CITY OF ALBUQUERQUE

November 12, 2021

Re: OSH – Montano Rd
333 Montano Rd. NW
30-Day Temporary Certificate of Occupancy
Transportation Development Final Inspection
Engineer's/Architect's Stamp dated 8-4-21 (F14D023)
Certification dated 11-10-21

Sheet Title
TRAFFIC CIRCULATION LAYOUT
Scale: As indicated
Drawn: JED
Project No.: 064559810
Sheet No.: **C201**

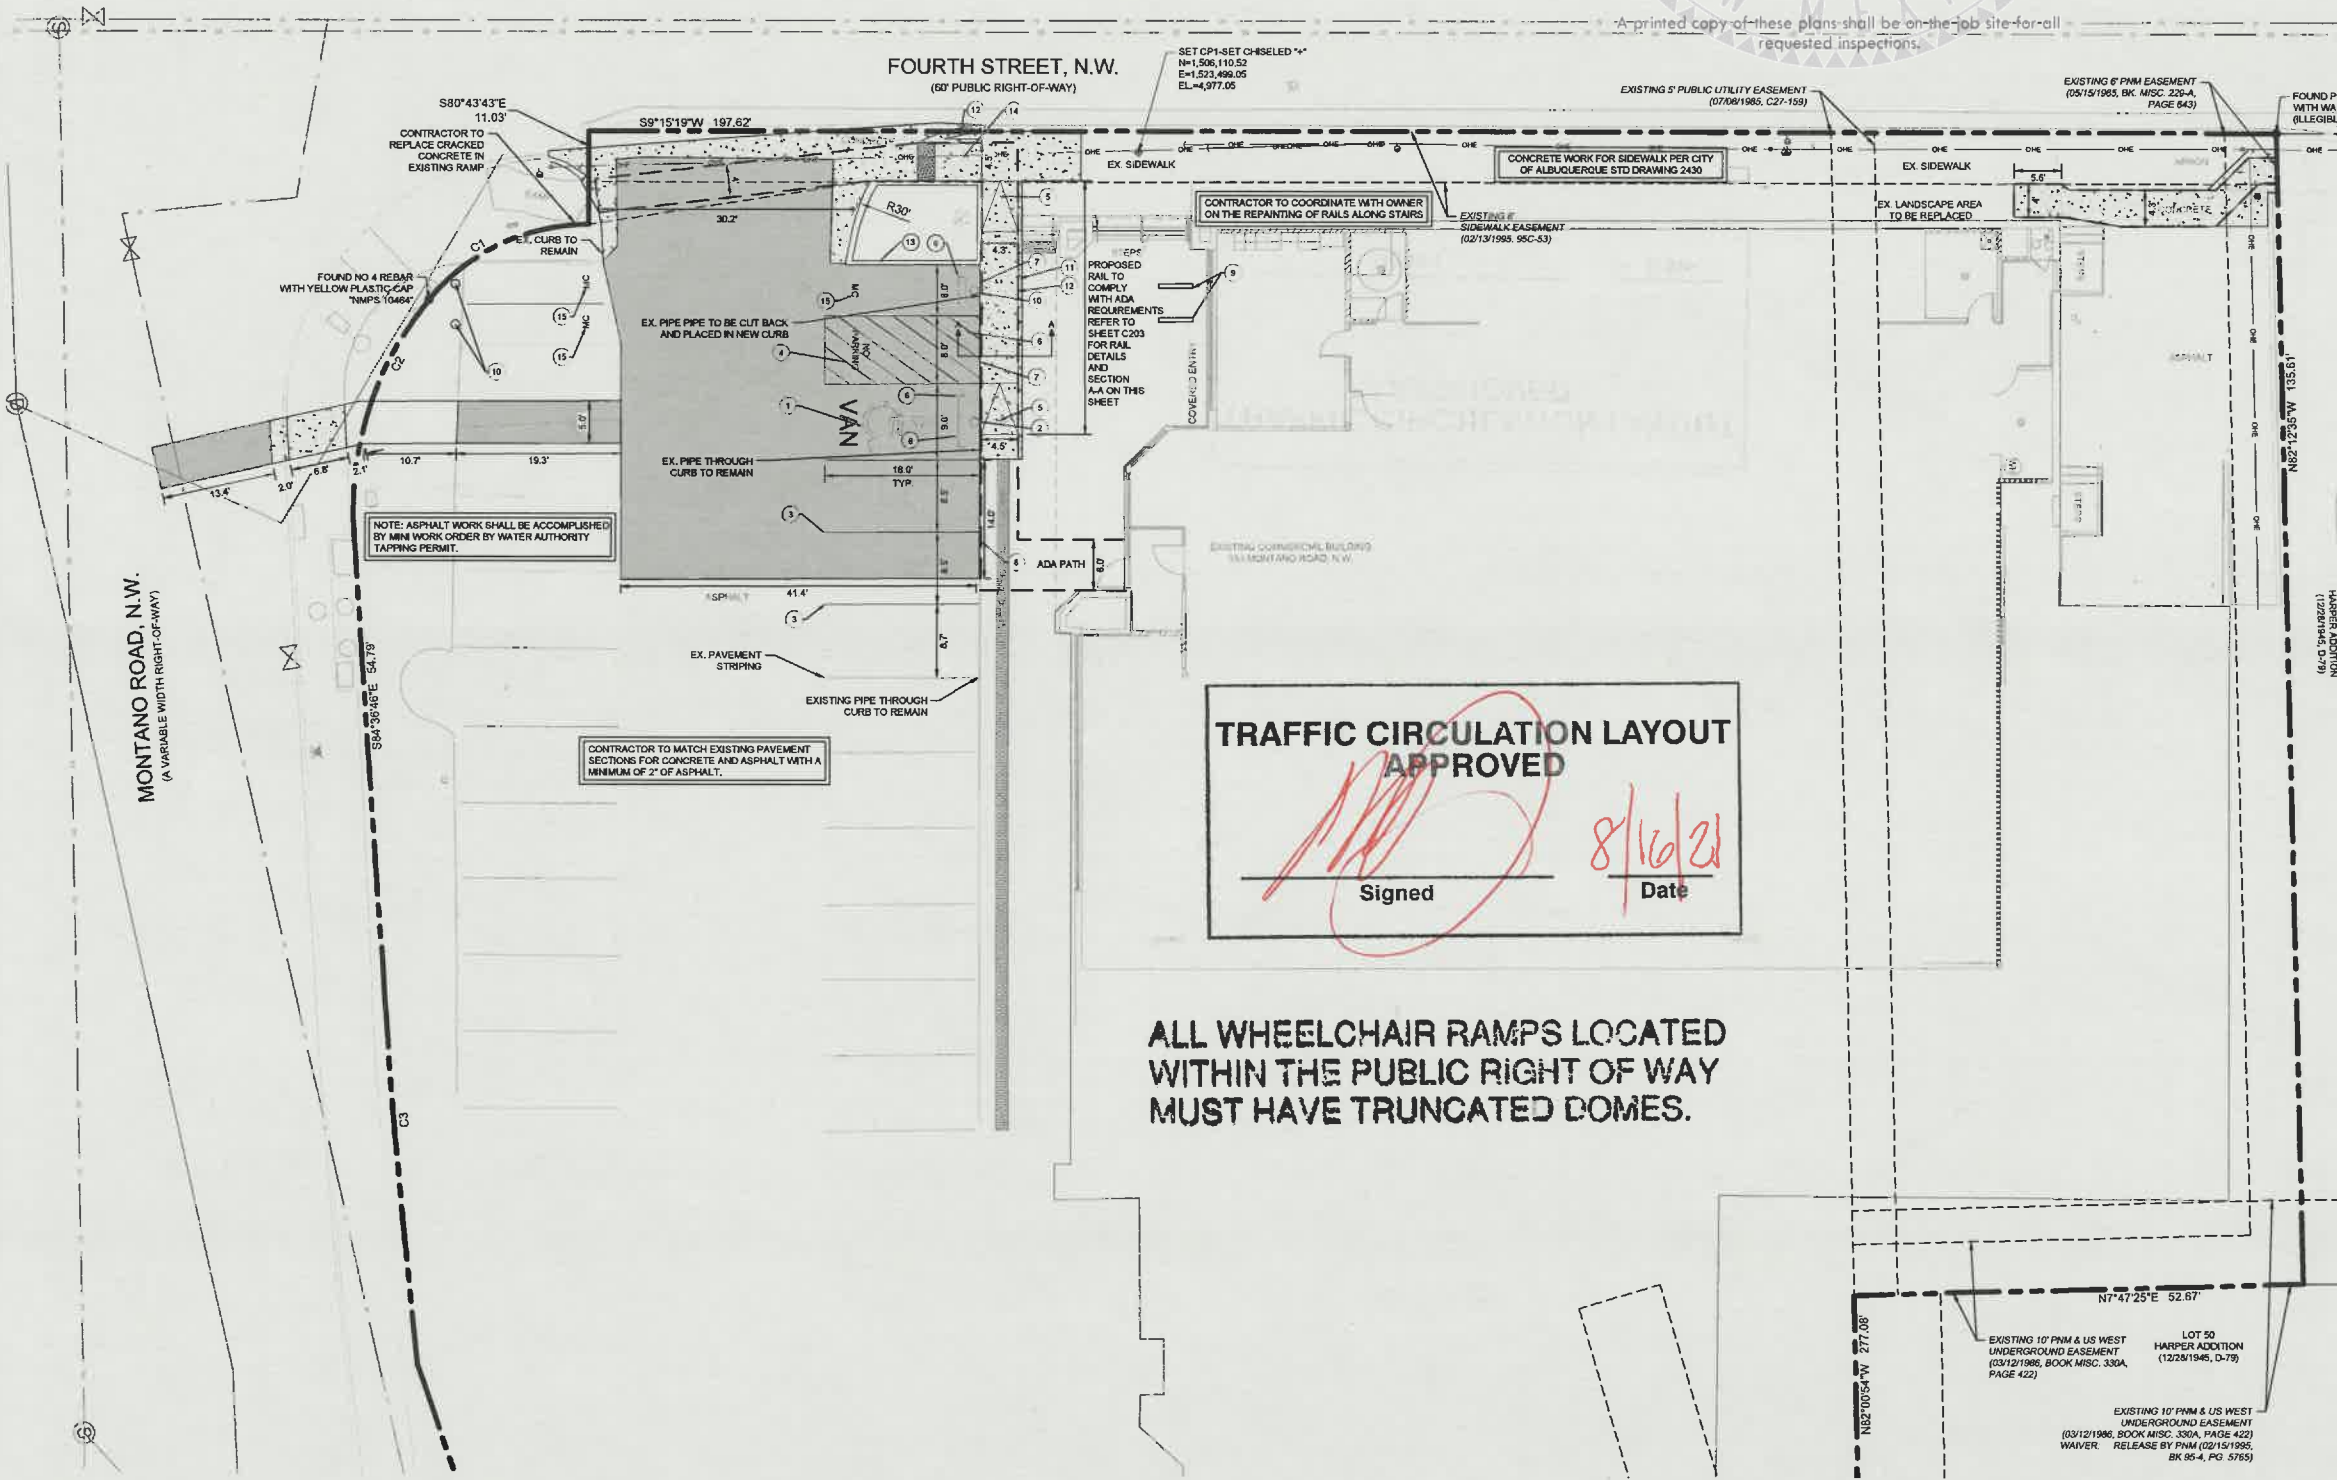
- The ADA access aisle shall have the words "**NO PARKING**" in capital letters, each of which shall be at least one foot high and at least two inches wide, placed at the rear of the parking space so as to be close to where an adjacent vehicle's rear tire would be placed. (66-1-4.1.B NMSA 1978)
- The ADA accessible parking sign must have the required language per 66-7-352.4C NMSA 1978 "**Violators Are Subject to a Fine and/or Towing.**" If that language is present it is not visible in the detail.
- Complete Landscaping.
- Remove porta potty, construction equipment and debris from site.

1. The approved and stamped TCL with changes drawn in red.
2. Transportation Certification letter on either the plan or applicants letterhead.
3. A Drainage Transportation Information Sheet (DTIS)
4. Send an electronic copy of your submittal to PLNDRS@cabq.gov.
5. The \$75 re-submittal fee for log in and evaluation by Transportation.
